Access Compliance Report

Public Rights-of-Way

Intersection ID: 31237	Main Street: SACKETT_WY	Cross Street: DAVID_COX_RD	Location: SE
ADA ID: 82F68D9460C8	Ramp Type: BlendTrans1	Initial Pass/Fail: Fail	Overall Compliance: No
Severity Score: 33.75			
Codes/Mitigation Info/Possible Solution		Field Measurements/Component Compliance

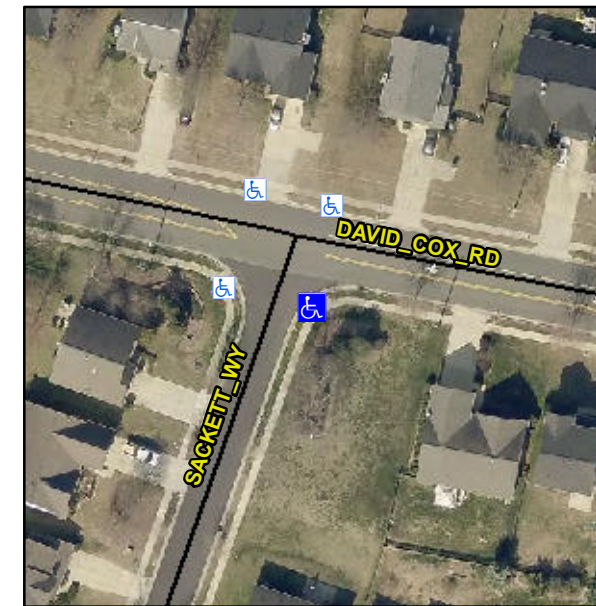
R304.5.1, R304.5.3

Compliance	Description	Data	Compliance	Description	Data
N/A	Ramp Length (in)	45.0	Yes	BlendTrans Slope (%)	2.6
No	Ramp Width (in)	47.0	No	BlendTrans XSlope (%)	10.0
N/A	Flare Type LT	N/A	N/A	Flare Type RT	N/A
N/A	Flare Slope LT (%)	N/A	N/A	Flare Slope RT (%)	N/A
N/A	Flare Traversable LT?	N/A	N/A	Flare Traversable RT?	N/A
N/A	Landing Length (in)	N/A	N/A	DWS Provided?	N/A
N/A	Landing Width (in)	N/A	N/A	DWS Contrast?	N/A
N/A	Landing Slope (%)	N/A	N/A	DWS Length (in)	N/A
N/A	Landing X Slope (%)	N/A	N/A	DWS Full Width?	N/A
N/A	Landing Curb? (Y/N)	N/A	N/A	DWS Offset (in)	N/A
N/A	Shared Landing?	N/A			
N/A	Gutter Ponding?	N/A	N/A	Gutter Slope (%)	N/A
N/A	Gutter Lip Ht (in)	N/A	N/A	Gutter X Slope (%)	N/A
N/A	Painted X Walk1?	No	N/A	Painted X Walk2?	No
	X Walk 1 Direction	To N		X Walk 2 Direction	To W
	X Walk 1 Width (in)	N/A		X Walk 2 Width (in)	N/A
	X Walk 1 Slope (%)	9.5		X Walk 2 Slope (%)	3.7
	X Walk 1 X Slope (%)	4.0		X Walk 2 X Slope (%)	9.8

Remove & Replace Curb Ramp With Two New Directional Ramps or Equivalent.
